AMENDMENTS TO THE DRAWINGS

Attached hereto are five (5) sheet(s) of corrected formal drawings that comply with the provisions of 37 C.F.R. § 1.84. The corrected formal drawings incorporate the following drawing changes:

FIG. 4

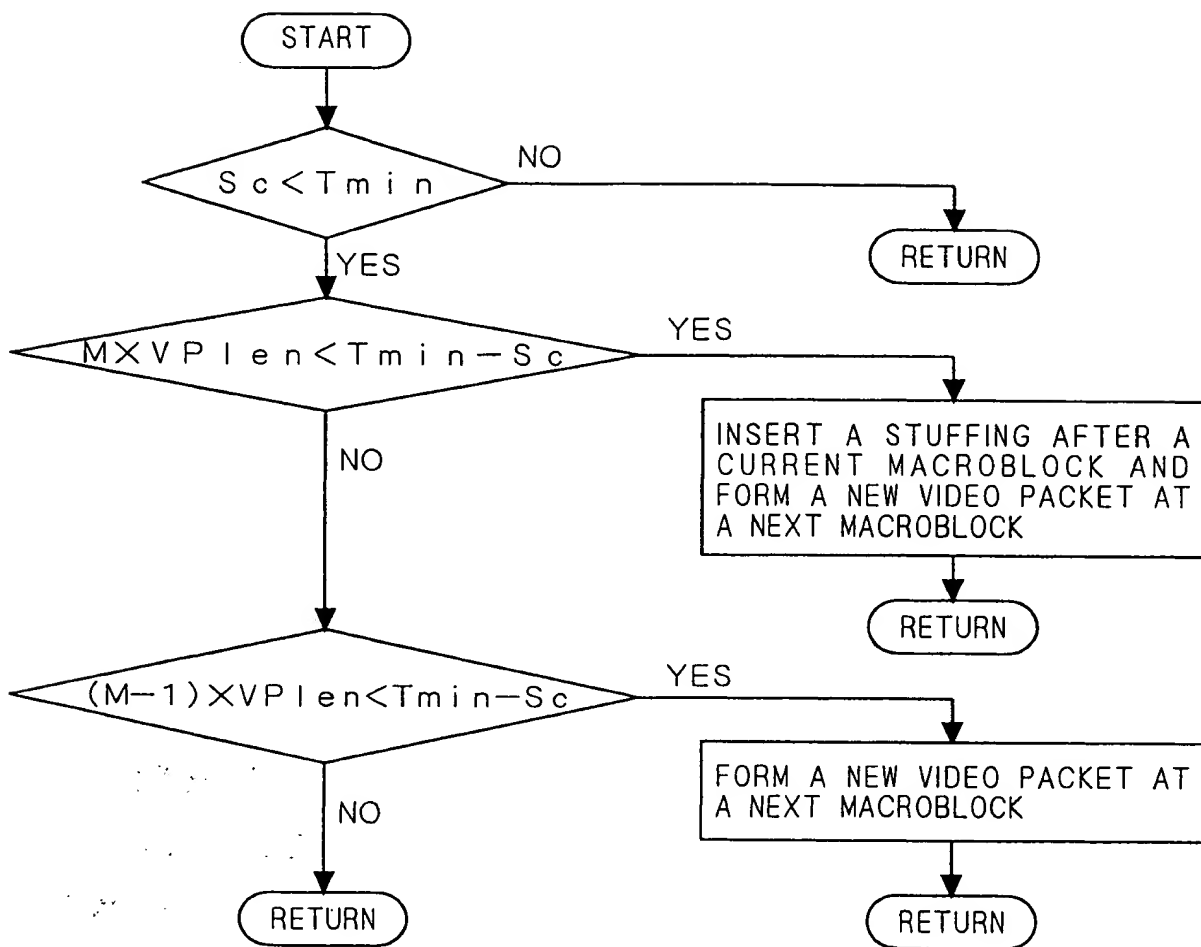
Fig. 4 – Please correct “MACROBROCK” to --MACROBLOCK--.

FIG. 6  
CONVENTIONAL ART

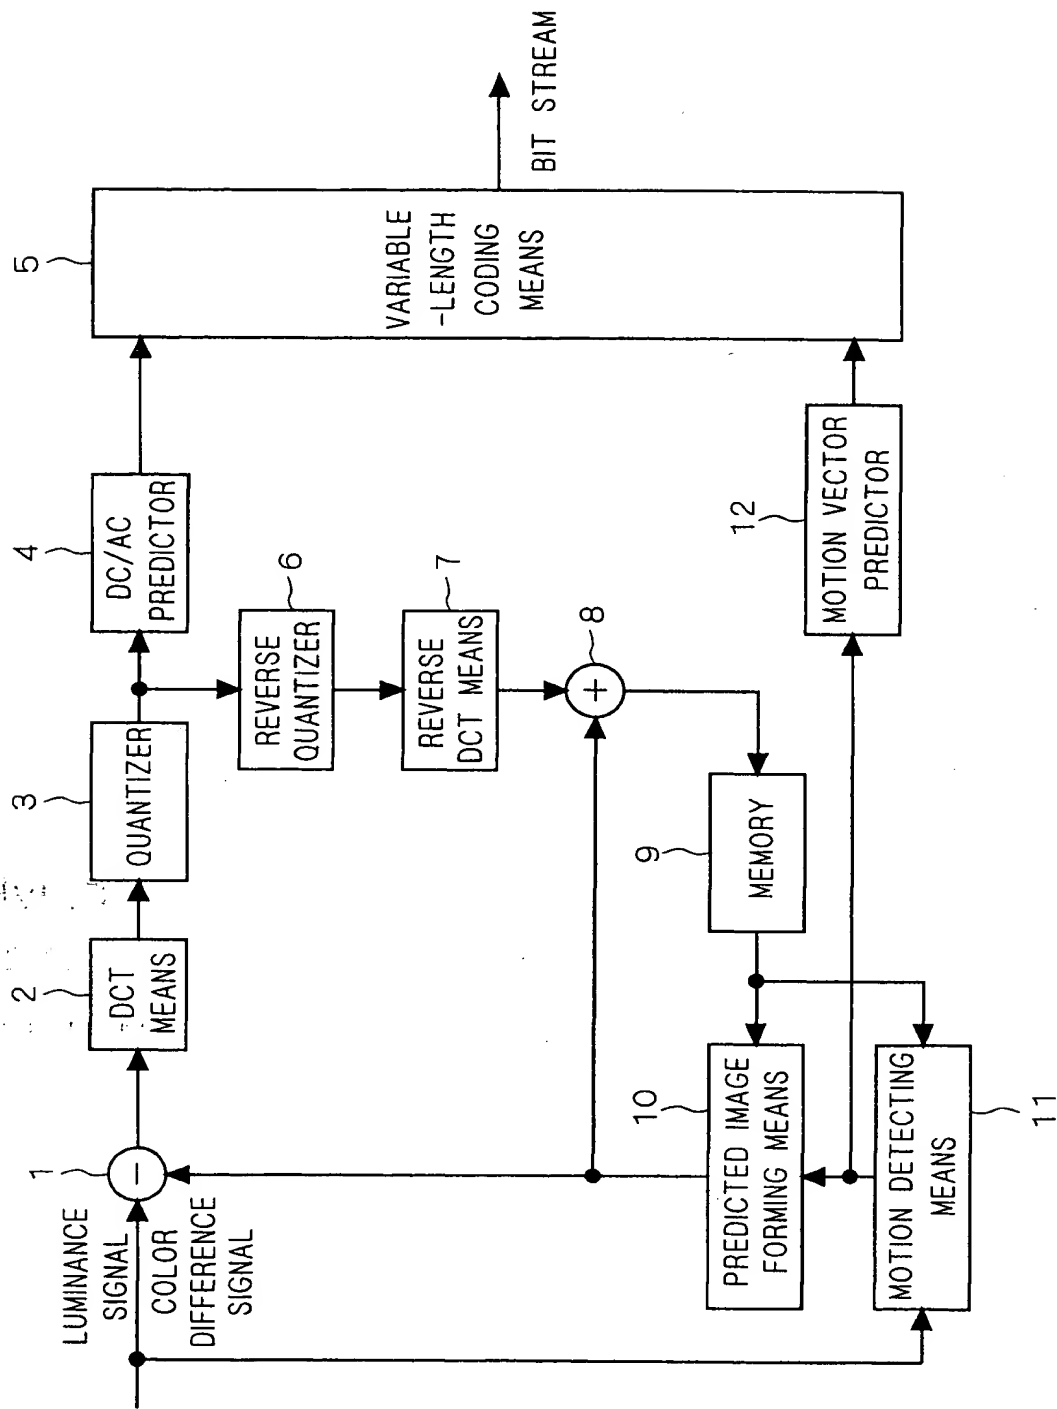
Figs. 6, 7, 8A and 9, please label as “CONVENTIONAL ART”.
